**Swords to City
Centre Core
Bus Corridor Scheme**

**NTA Observations on
the Proposed Scheme
Submissions**

November 2023

Figure 2.33 Proposed General Arrangement in between Omni Park Shopping Centre and Shanowen Road (Sheet 21)

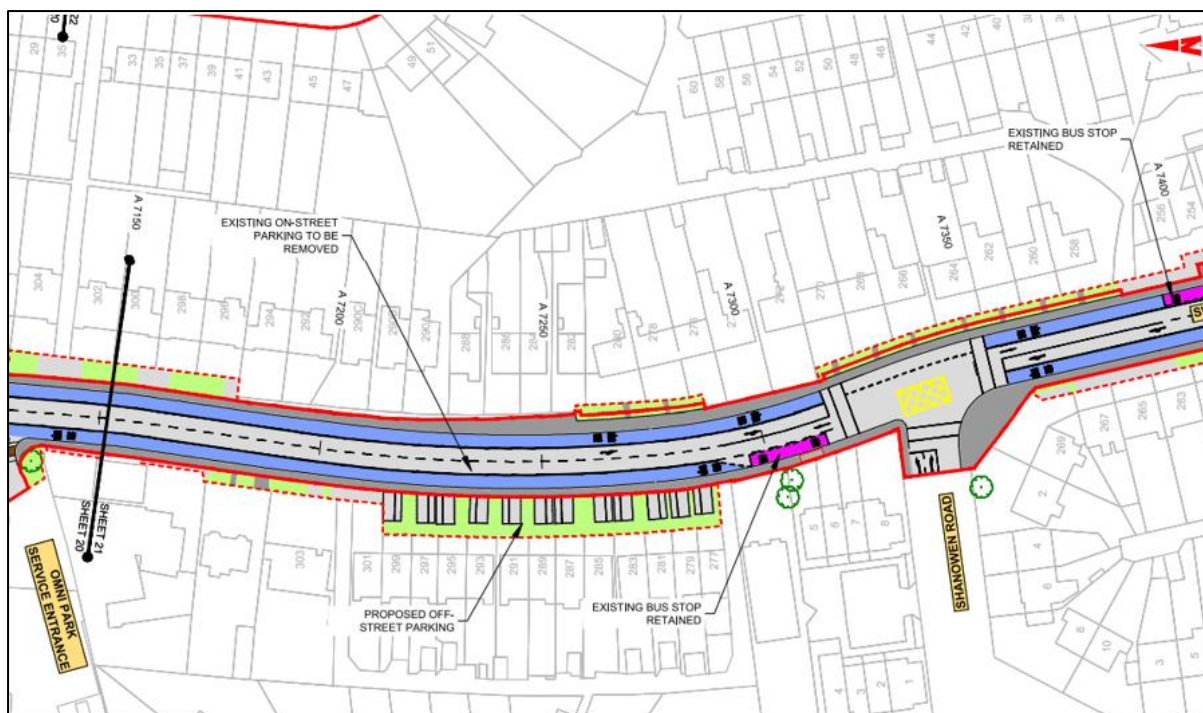
It is understood that this comment refers to the on-street parking north of Shanowen Road. This suggestion has already been implemented as part of the Proposed Scheme, see Figure 2.33. As described in Section 4.5.3.1 of Chapter 4 Proposed Scheme Description of Volume 2 of the EIAR,

'Between the Omni Park Shopping Centre entrance and the Shantalla Road junction it is proposed to maintain the two-way general traffic lanes and introduce continuous bus lanes in both directions. A segregated footpath will be maintained on either side. This will require some land take from adjacent properties on both sides of the existing road in Santry Village and the removal of existing on-street car parking. Off street parking is proposed at residential properties between the shopping centre and Shanowen Road to offset the loss of on-street parking. Off street parking is proposed at residential properties between the shopping centre and Shanowen Road to offset the loss of on-street parking.'

Figure 2.53 Extract from General Arrangement Drawing (Sheet 34)

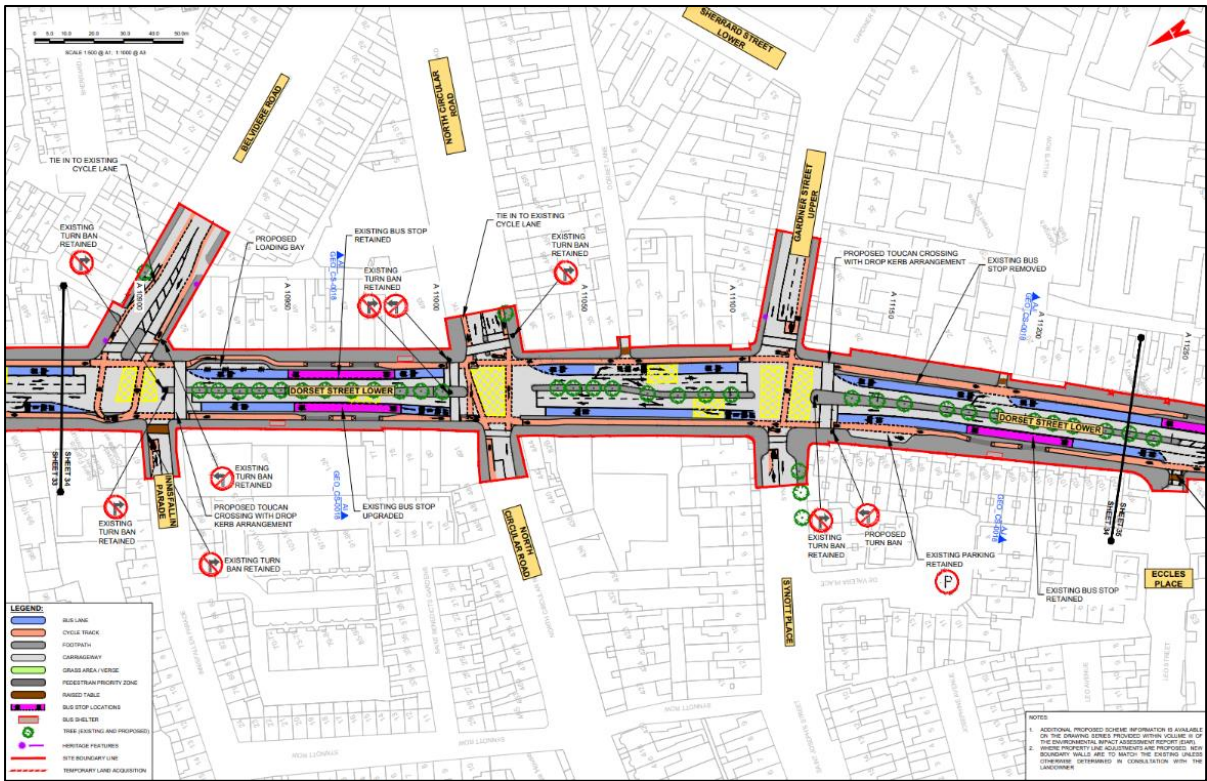
- Sheet 34- a relocated bus stop from a location where no bus stop currently exists. (A11150);
- Sheet 34: Loading bay on Dorset Street marked as proposed but these are existing and appear to be reduced in number;
- Sheet 35- incorrectly shows an exception to a right turn ban for motorcycles, cycles and public services up the one way Blessington Street. The left turn ban (with exceptions) for North Frederick Street is missing. (A11450-11500);
- Sheet 35- incorrectly shows a pedestrian crossing, where none currently exists (Ch A11550).

- Sheet 34: It is noted that the bus stop at Ch A11150 on Map 34 no longer exists.
- Sheet 34: It is confirmed that the existing loading bays are to be reconfigured such that the proposed cycle track will pass behind the loading bays as shown on Drawing 34. The number of loading bays will remain the same as existing.
- Sheet 35: It is confirmed that the right turn ban from Dorset Street to Blessington Street is for all vehicles, and the existing left turn ban from Dorset Street to North Frederick Street) Except Public Service Vehicles, Motorcycles and cycles) is retained.
- It is confirmed that the pedestrian crossing at Ch A11550 is a proposed pedestrian crossing.
